SAN ONOFRE

RECENT GEOTECHNICAL STUDIES
SOUTHERN ORANGE COUNTY, CALIFORNIA

ENCLOSURE 1
RESPONSE TO NRC QUESTIONS

NRC COMMENTS AND QUESTIONS REGARDING

| | DRAWING NO. 1 |

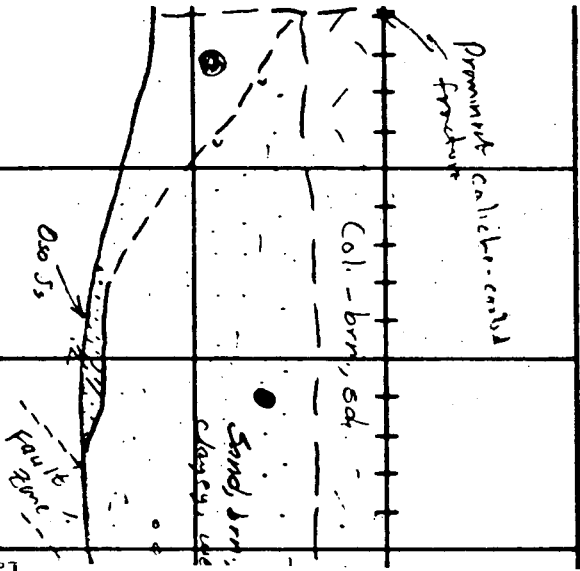
zinal trench length and other marker points, seems in error (twice as large). A scale of reliable data and seems to be correct. This place the "prominent caliche-coated fracture" e same location as the lime-filled fracture t excavation log (Drawing 4). Scale is as

4. Detailed examination of the northwest wall revealed three lime- (carbonate) filled cracks in the colluvium in the area of stations 35 and 40. No lime-filled crack was found over the Cristianitos fault. A comparison of the original F. Beach Leighton trench log (Drawing 1) and photograph no. 2 in Fife (1974) California Division of Mines and Geology Special Report No. 110, indicates that the lime-filled crack described by Fife (1974) does not coincide with the Cristianitos fault. It is more accurately located 10 to 12 feet west of the western edge of the fault, and is probably correlative with one of the three carbonate-filled cracks observed in the present trench (Drawing 4).
